FirstEnergy Nuclear Operating Company

February 27, 2013
L-13-076

Davis-Besse Nuclear Power Station
Docket No. 50-346, License No. NPF-3
10 CFR 50.55a Notification of Impracticability and Requests for Alternatives Supporting
the Third and Fourth 10-Year Inservice Inspection Intervals

Figure 5-4: Schematic Configuration for FSWOL for RCP Cold Leg Drain Line Nozzles

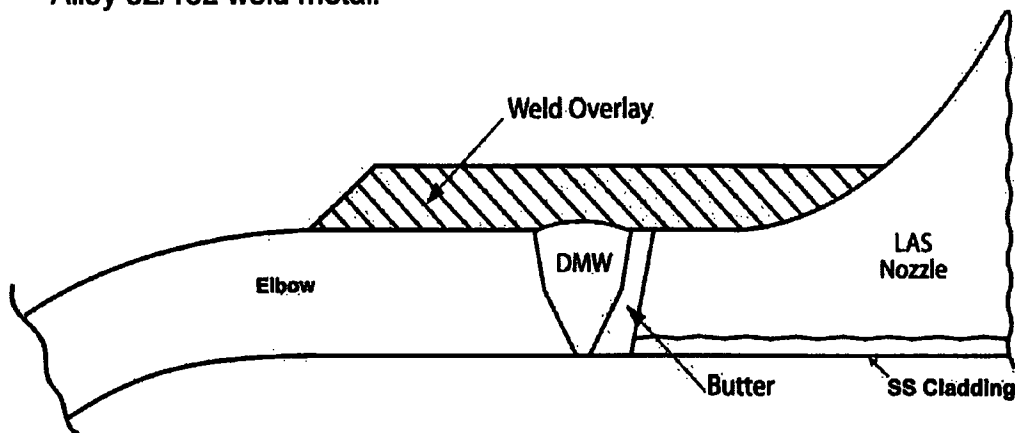
Reactor Coolant System Cold Leg Drain Line Dissimilar Metal Welds

The reactor coolant pump inlet (RCP) lines have a drain connection at the low point of the line. Each cold leg drain nozzle is a vertical 2 ½ inch carbon steel nozzle that is welded to the carbon steel reactor coolant piping, and is internally clad with stainless steel. The dissimilar metal weld is fabricated from Alloy 82/182 weld metal.

As authorized by Request RR-A33, FENOC applied a full structural Alloy 52M weld overlay on dissimilar metal weld RC-40-CCA-18-3-FW9 during the spring 2010 refueling outage.

Due to the configuration/geometry of this nozzle to elbow weld, achieving essentially 100 percent coverage of the examination volume is unattainable without a significant modification to the existing piping. Implementing this type of modification would require a core offload, flushing and draining of the system, and removing/replacing the existing piping with reconfigured piping. Based on radiological survey results from the spring 2012 refueling outage, this work would occur within radiation fields with dose rates up to 500 milli-Rem per hour, resulting in a significant increase in occupational radiation exposure [dose] to personnel.

In lieu of the essentially 100 percent coverage requirement, FENOC proposes crediting the aggregate coverage achieved (approximately 70 percent) from the spring 2012 examination. The accessible area was examined with techniques that have been demonstrated and qualified in accordance with Supplement 11 of ASME Section XI, Appendix VIII, for the manual phased array (PA) ultrasonic (UT) examination technique.

FIG. 2(a) EXAMINATION VOLUME IN FULL STRUCTURAL WELD OVERLAYS**Examination Volume A-B-C-D**

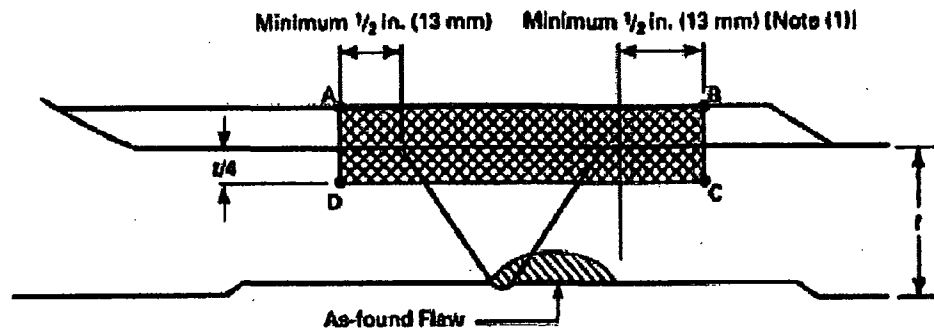
Code Case N-770-1, -2500(a) states welds shall be examined as specified in Table 1, with the volumetric examinations meeting the requirements of Appendix VIII. Per Table 1, Inspection Item F, Figure 2 provides the examination requirements. Figure 2(a) from the Code Case is provided below:

In accordance with Code Case N-770-1, Table 1, Inspection Item F, an initial inservice volumetric examination was completed during the spring 2012 refueling outage, which resulted in approximately 70 percent total aggregate coverage. As stated in the condition of 10 CFR 50.55a(g)(6)(ii)(F)(4), essentially 100 percent coverage is required; this examination coverage requirement was not achieved due to limitations imposed by the weld geometry. An image of the FSWOL is provided as Attachment 1 to this request. Details of the examination limitations are presented in Attachment 2 to this request. This request is processed in accordance with 10 CFR 50.55a(a)(3)(ii), as discussed in the J. W. Collins' memo to T. R. Lupold, which summarized a public meeting on Code Case N-770-1 (Reference 1).

Code Case N-770-1 and 10 CFR 50.55a(g)(6)(ii)(F)(4) define the required examination volume as essentially 100 percent coverage. The initial inservice examination was completed during the spring 2012 refueling outage. The essentially 100 percent coverage requirement was unattainable due to limitations imposed by the existing nozzle to elbow geometry. Due to these limitations, only 70 percent of the required examination volume was examined with the PA UT technique, which was qualified in accordance with Supplement 11 of ASME Section XI, Appendix XIII. The 70 percent aggregate coverage achieved, which consists of 69 percent axial and 71 percent circumferential composite coverage values, represents the maximum practical coverage obtainable within the limitations imposed by the existing geometry. As noted in Attachment 2 to this request, there were no recordable indications identified in this weld that exceeded the acceptance criteria of ASME Section XI. Additionally, a visual VT-2 examination was performed on this weld during the Class 1 pressure test prior to startup from the spring 2012 refueling outage. This visual examination identified no evidence of leakage.

Figure 1

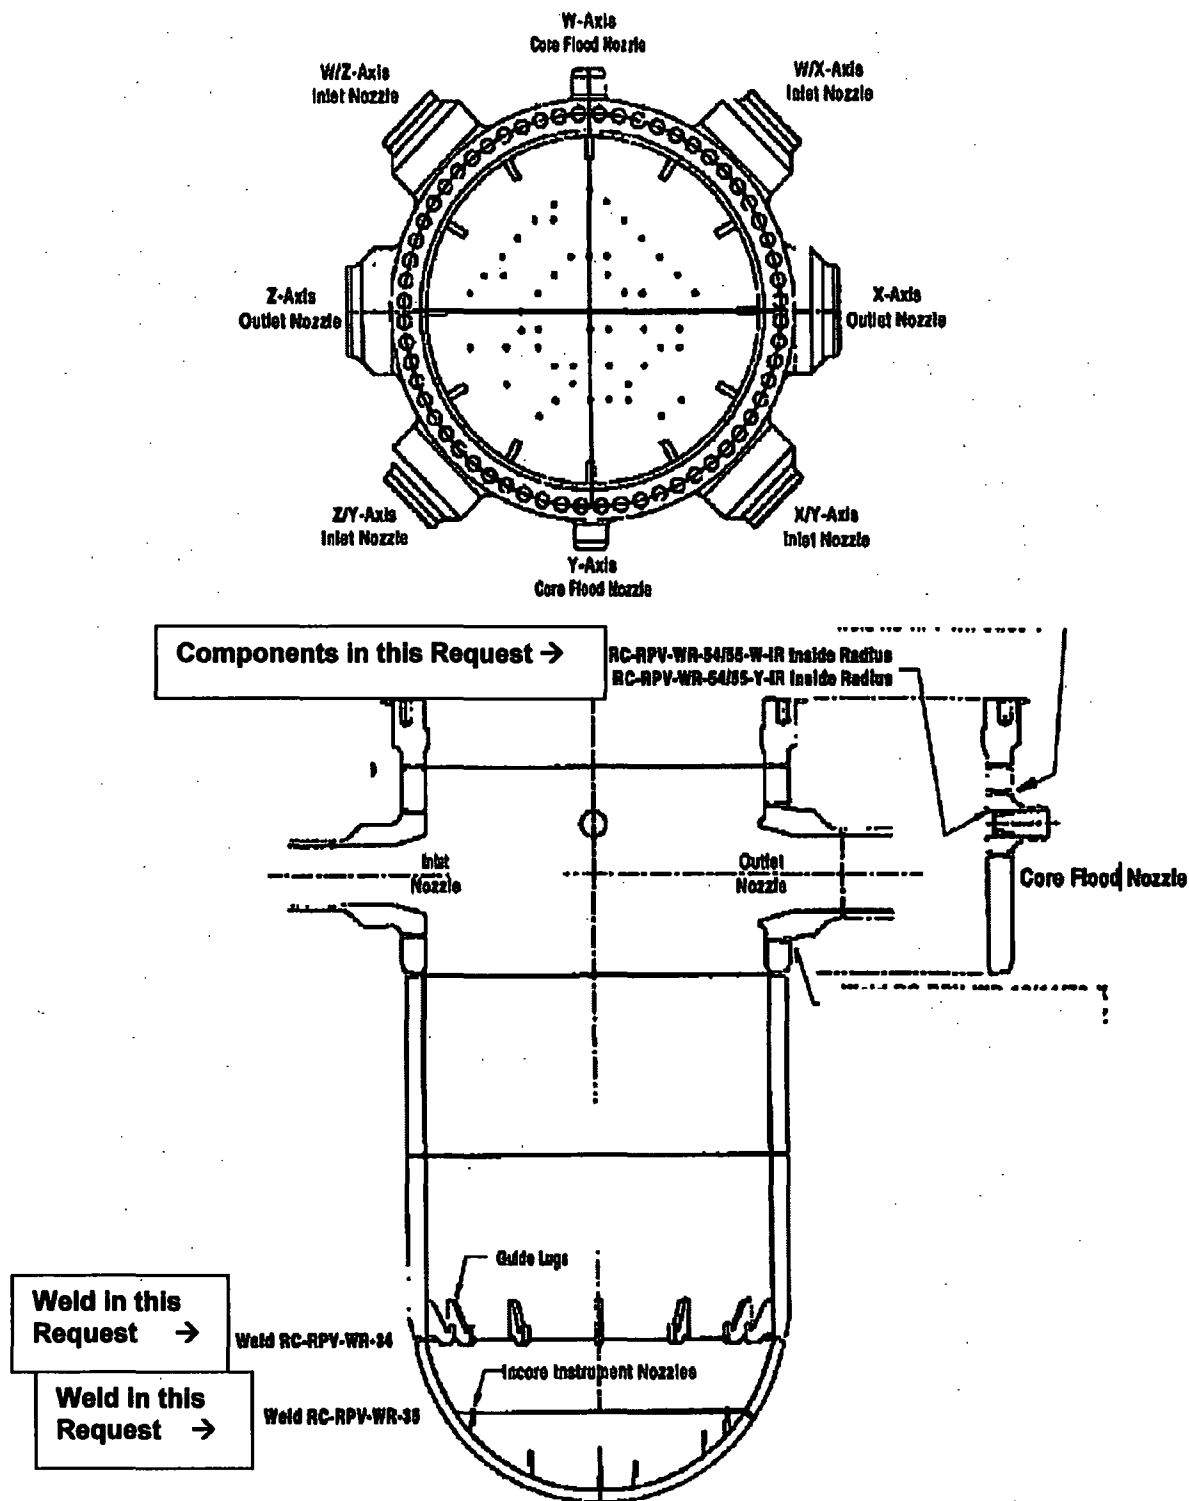
ASME Class 1 welds in the Reactor Pressure Vessel (Figure 1 depicts locations):

ASME Class 1 components in the Reactor Pressure Vessel (Figure 1 depicts locations):

Figure 2A

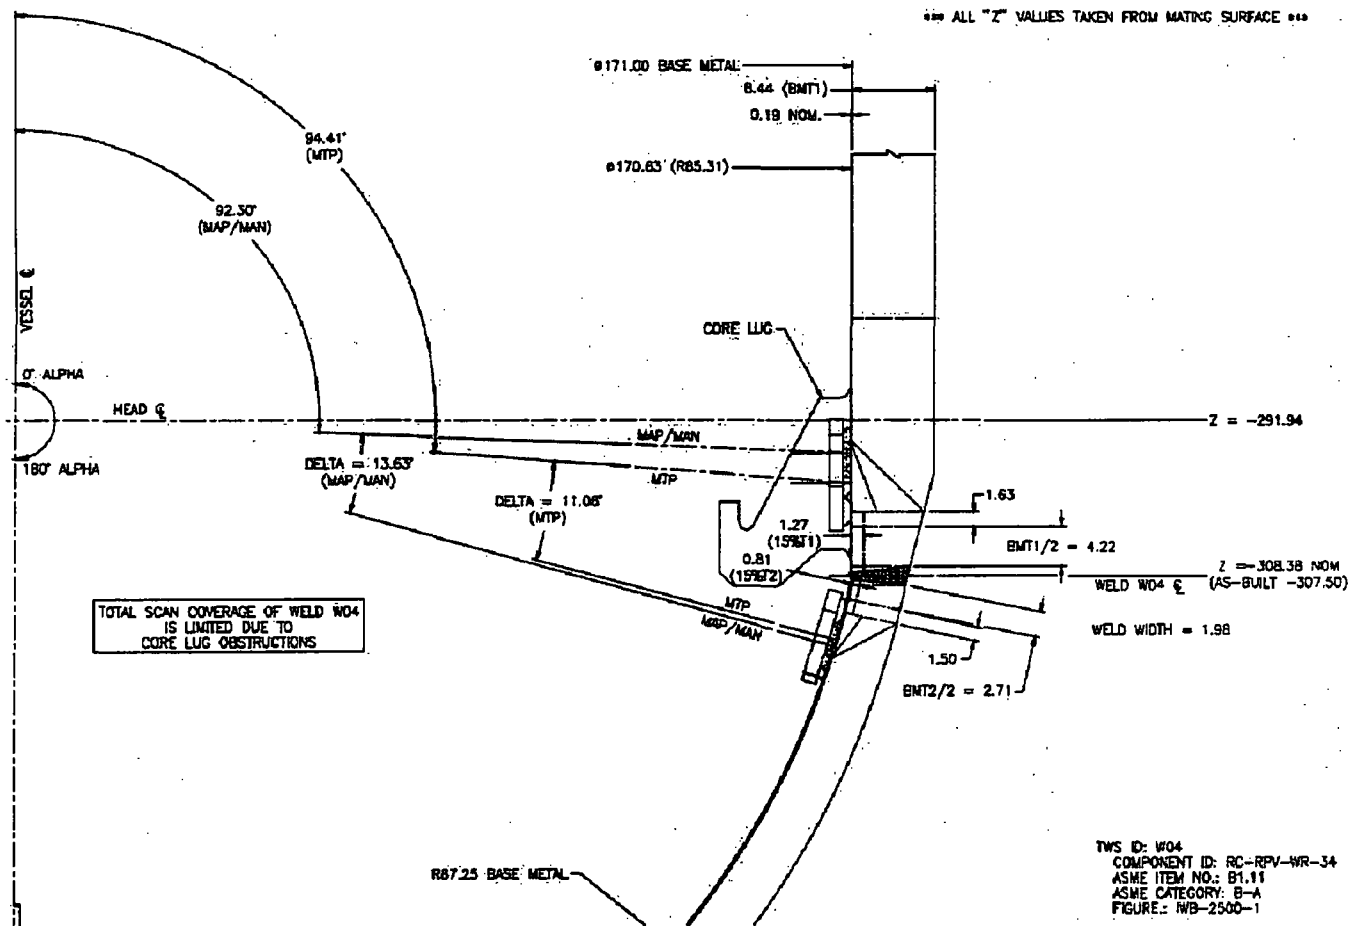
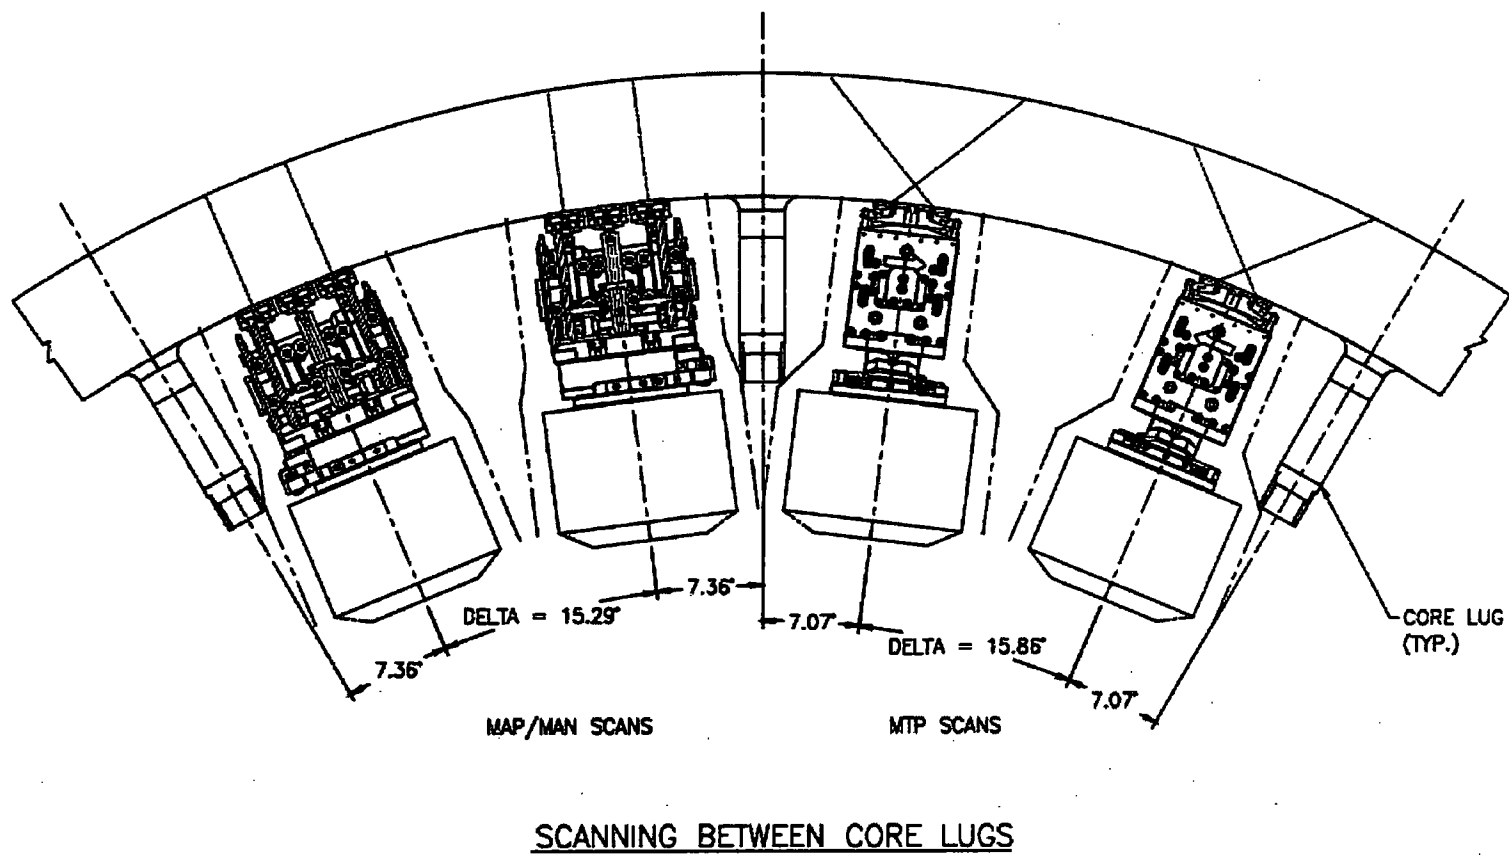
Figure IWB-2500-1 defines the required examination volume. Ultrasonic interrogation of greater than 90 percent of this volume cannot be obtained due to interferences caused by the core guide lugs. The core guide lugs are welded to the reactor vessel shell just above the lower shell to bottom head weld and extend approximately 2 inches below the centerline of the weld. These lugs restrict the TWS manipulator's ability to move to areas necessary to fully examine the required volume. Access to approximately 42 percent of the examination volume is restricted. The remaining 58 percent of the examination volume has been examined using the TWS and ACCUSONEX system. This examination has been performed from the inside surface of the reactor vessel by scanning the weld and adjacent base material areas above and below the weld. Examination scanning directions were both parallel and perpendicular to the weld axis. In addition to the required ultrasonic examination, the welds attaching the core guide lugs have received a VT-3 visual examination in accordance with Table IWB-2500-1, Examination Category B-N-2, Item B13.30, "Interior Attachment Welds Beyond Beltline Region." This VT-3 examination confirmed the lack of relevant conditions for the core guide lug welds, which would have indicated if the area of the lower shell to bottom head weld had been subjected to any excessive loads.

This weld was last examined during the third interval 10-year reactor vessel examination (October 2011). The examination volume achieved during this examination (approximately 58 percent) was similar to that achieved during the second interval 10-year reactor vessel examination. There have been no indications identified in this weld that exceed the acceptance criteria of ASME Section XI. The UT data sheet, flaw evaluation summary sheets, and UT scan plan for this weld are provided in the attachment to this request.

Figure 3A

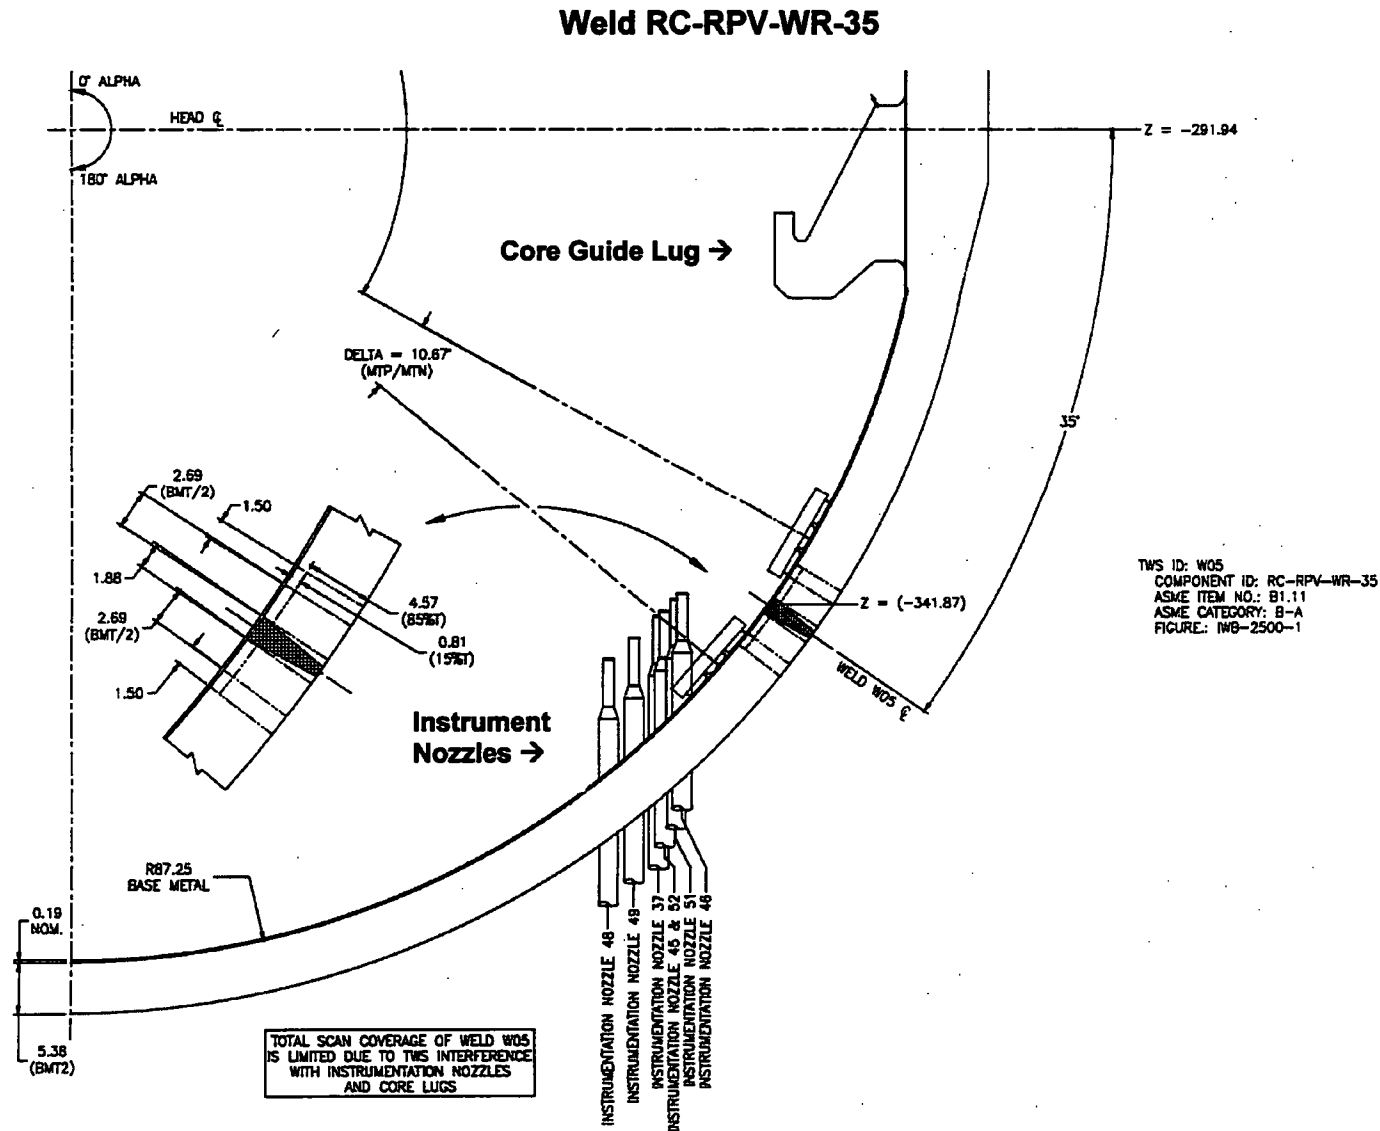
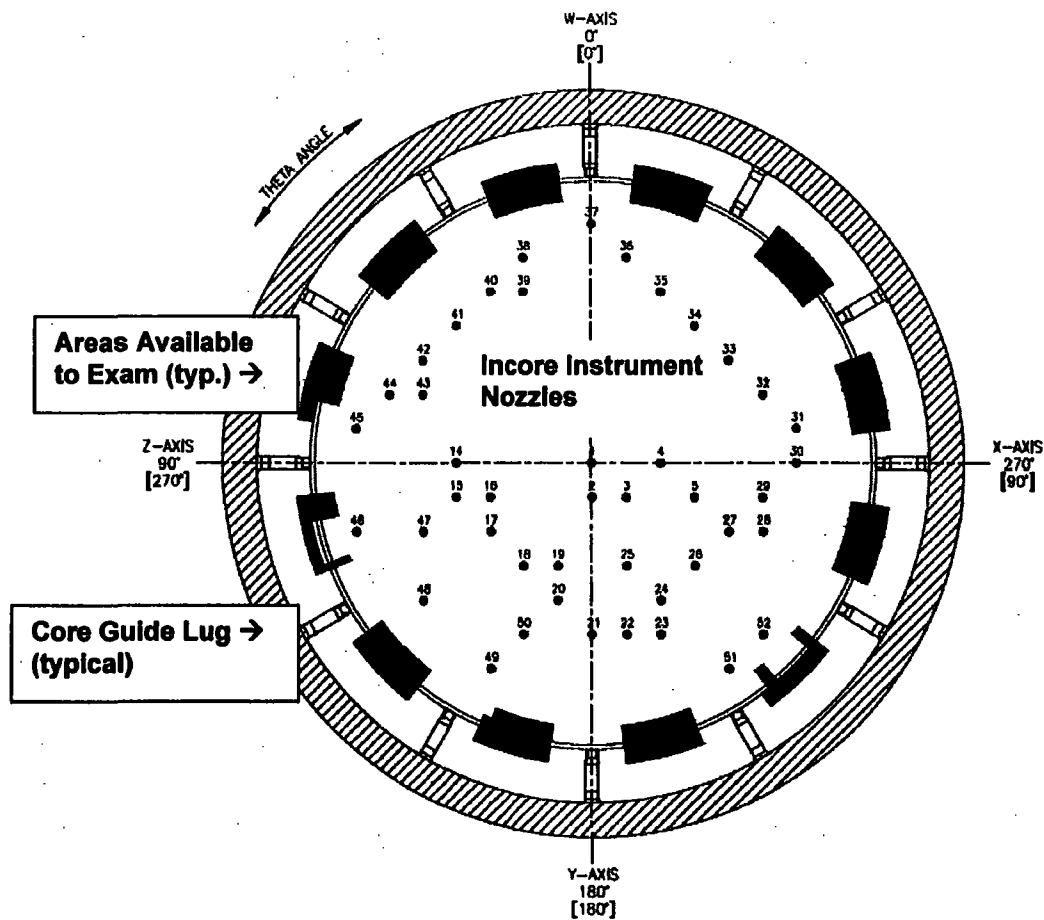
Figure IWB-2500-3 defines the required examination volume. Ultrasonic interrogation of greater than 90 percent of this volume cannot be obtained due to interferences caused by reactor vessel incore instrument nozzles and core guide lugs. These instrument nozzles protrude through the bottom head of the reactor vessel to a height of approximately 1 foot from the inside surface of the bottom head. Access to approximately 54 percent of the examination volume is restricted. The remaining 46 percent of the examination volume has been examined using the TWS and ACCUSONEX system. These examinations have been performed from the inside surface of the reactor vessel by scanning the weld and adjacent base material areas above and below the weld. Examination scanning directions were both parallel and perpendicular to the weld axis.

Figure 4

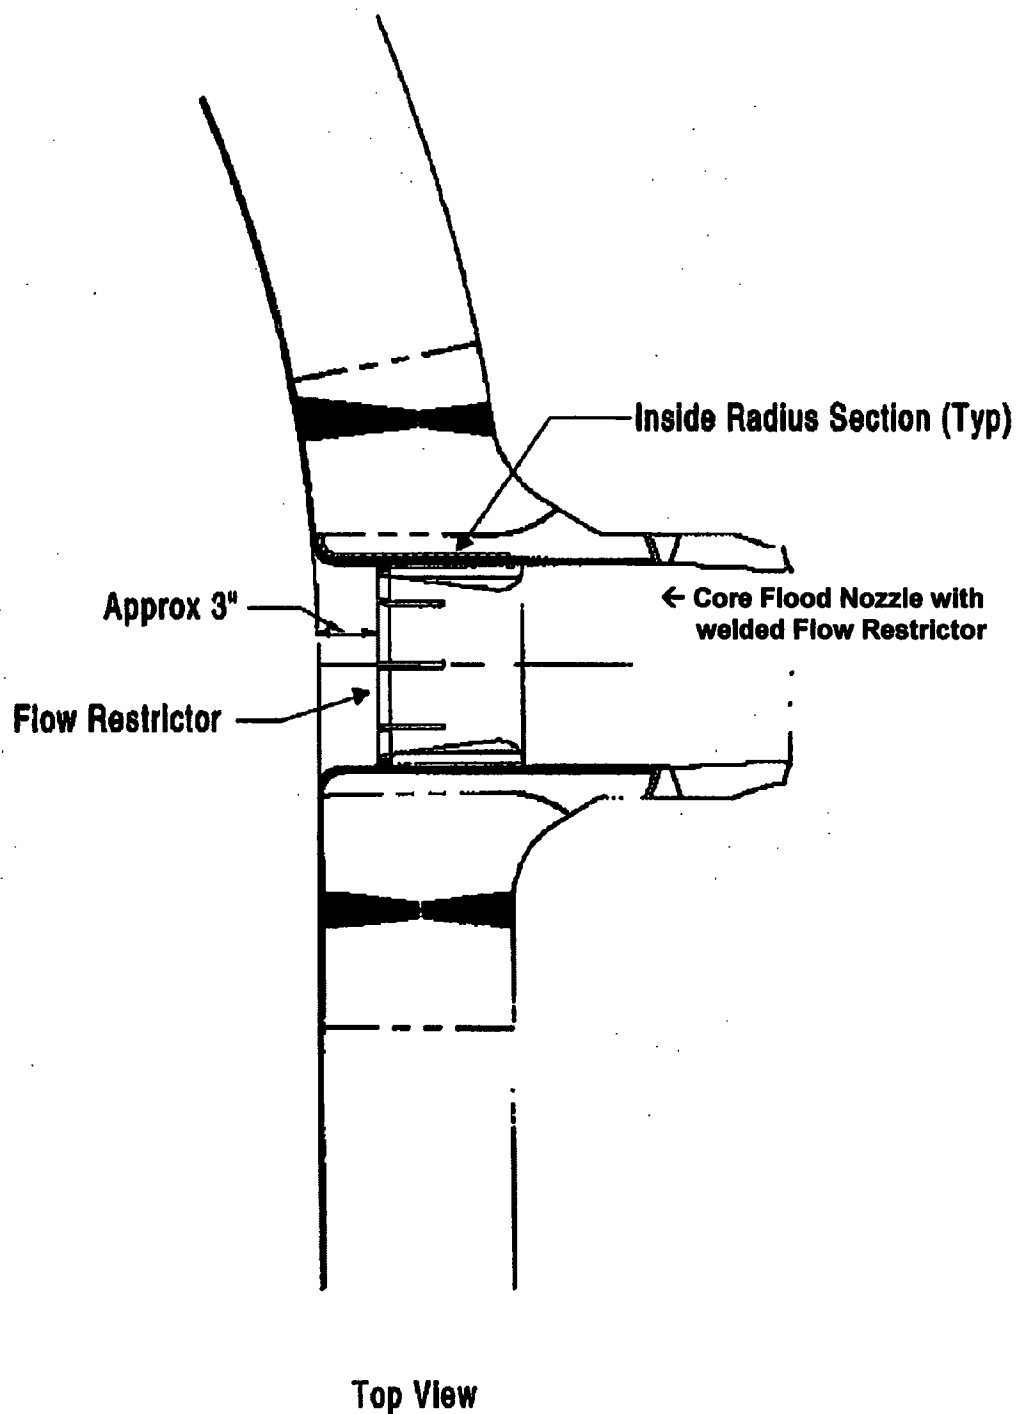
Figure 4 in this request depicts the Core Flood Nozzle Inside Radius Sections (Component Numbers RC-RPV-WR-54/55-W-IR and RC-RPV-WR-54/55-Y-IR).

Table IWB-2500-1, Examination Category B-D, Item B3.100 requires a volumetric examination as depicted in Figure IWB-2500-7. As an alternative to this requirement, Code Case N-648-1 (approved for use in Regulatory Guide 1.147, with conditions) allows performance of an enhanced visual examination (EVT-1) to satisfy this requirement. The area of interest for the EVT-1 is the external surface of Figure IWB-2500-7(b), as defined by the condition in Regulatory Guide 1.147. Due to flow restrictors located inside the bores of the core flood nozzles, neither the UT nor the EVT-1 visual examinations could achieve the required examination coverage of greater than 90 percent. Because these flow restrictors are welded into the nozzles, their removal is not practical. The flow restrictors prohibit all UT examinations from the nozzle inside diameter. As a result, a limited EVT-1 visual examination was performed in lieu of the UT examination. The coverage obtained by the EVT-1 examination was 360 degrees around the nozzle, from the nozzle to vessel weld, to a distance approximately 3 inches deep inside each nozzle's bore. For each nozzle this resulted in approximately 25 percent of the inside radius area of interest receiving a visual examination.
